Regency Three Limited (Unit-5)

Plot 27-30 & 43-48, Sector-8, CEPZ, Chittagong, Bangladesh

20th November, 2016

Discrepancies Between As- Built Structural Drawing and On Site Condition

Section of sub-beam

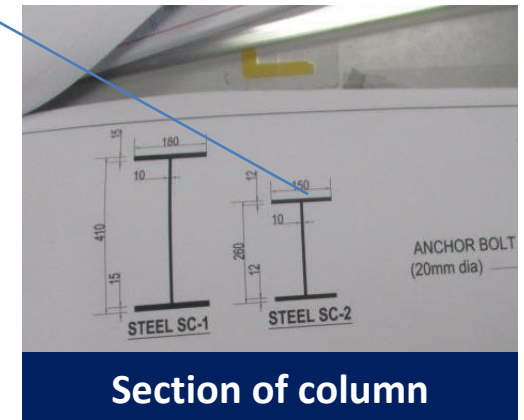
The thickness of flange does not match with drawings. The size of sub beam did not match with provided drawings. Factory engineer required to update the as built drawing and also check the adequacy of structure member as per site condition.

Non Engineered Sheds

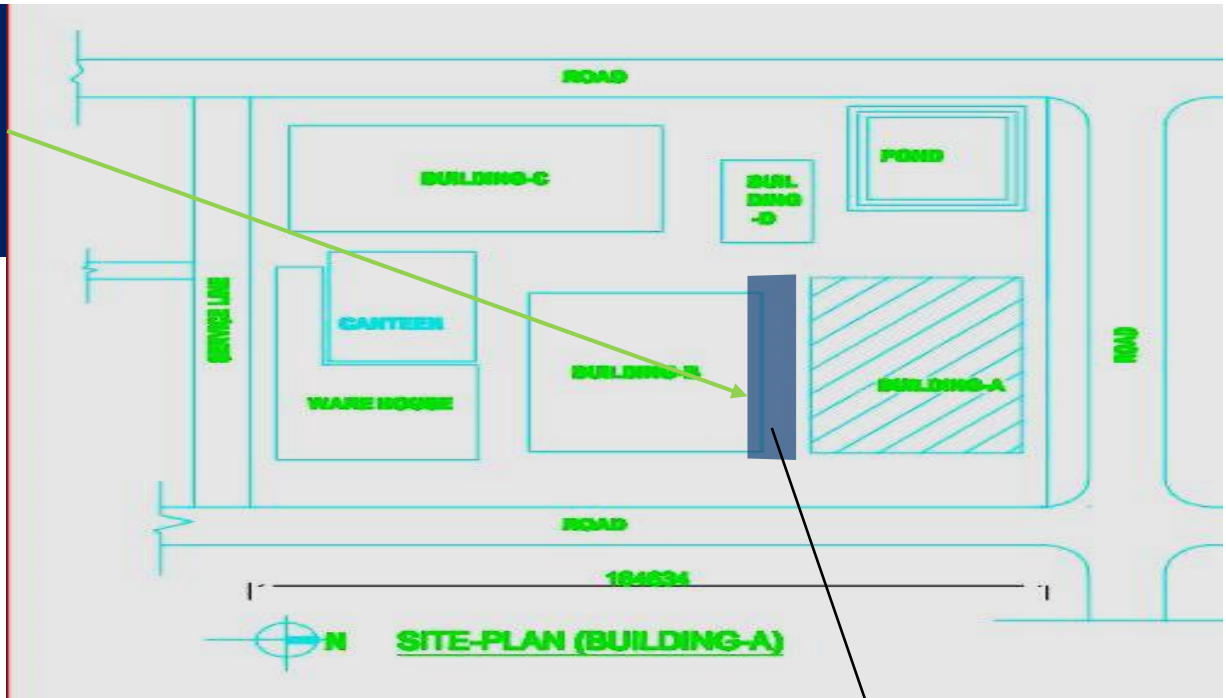
steel sheeting supported by steel purlin/angle system on wall or steel posts. Connections appear non-engineered. Factory engineer to verify the adequacy of connection and steel member against wind load.

Corrosion on Vertical Bracing at Building B

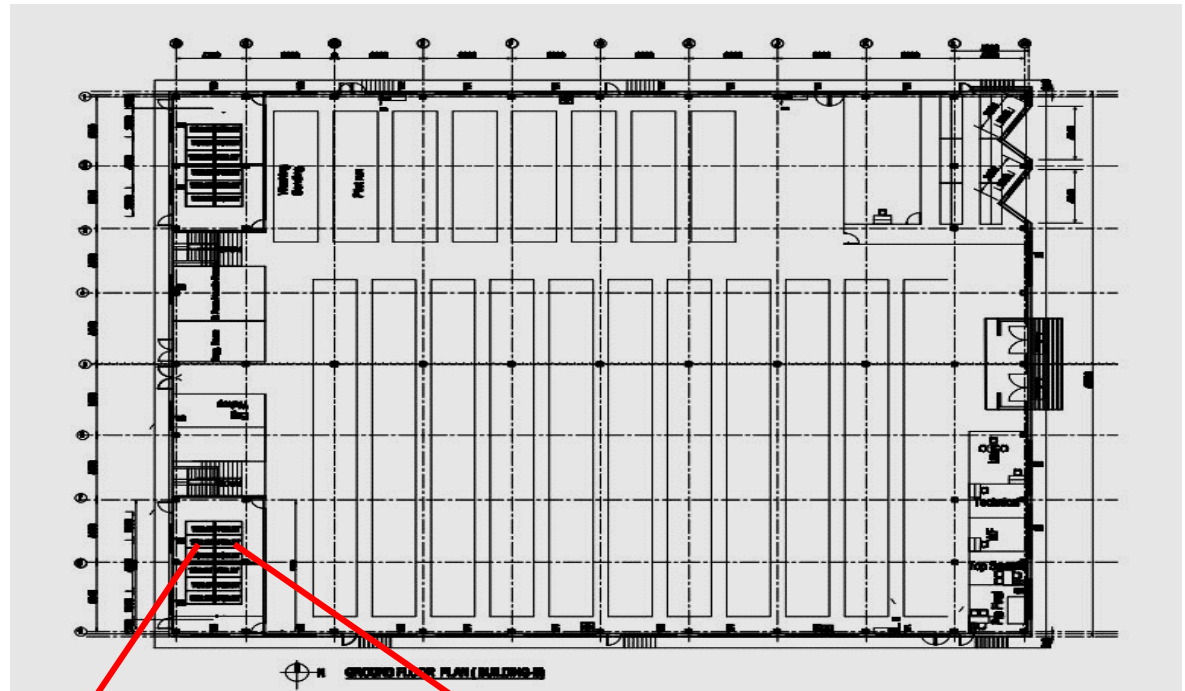
Vertical bracing in the toilet zone in Building B was seen badly corroded.

Appearance of Cracks on Masonry Wall at Building-A,B &C

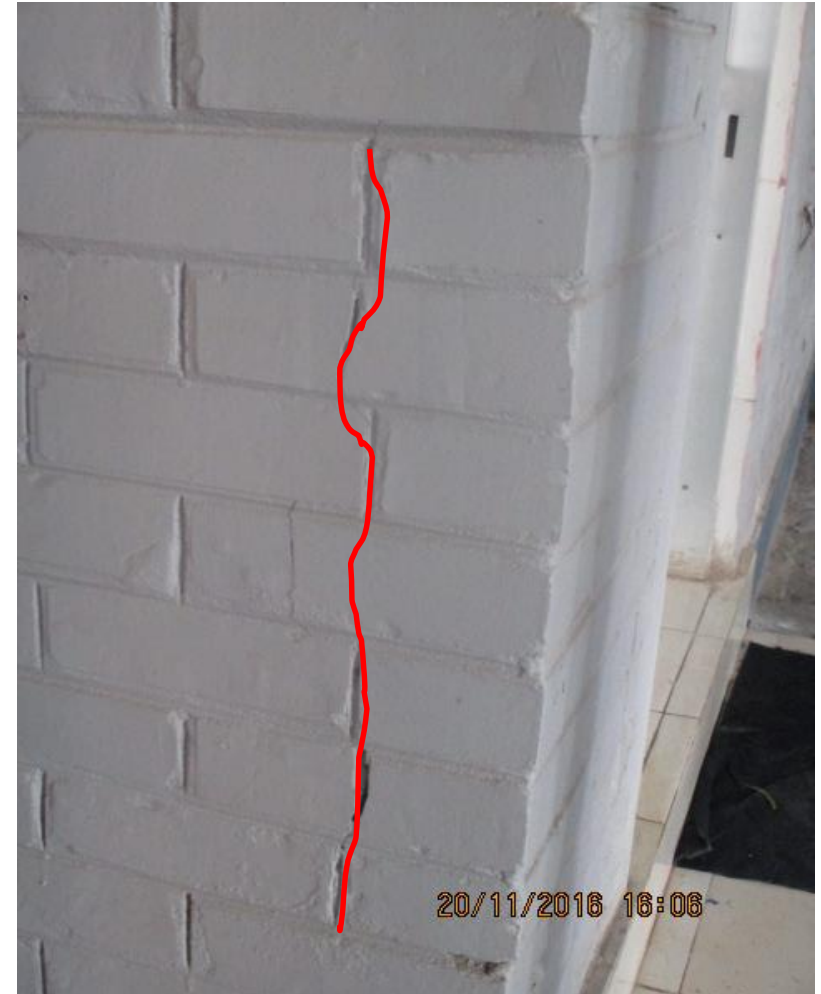
Crack n the masonry walls in Building A , B and C.
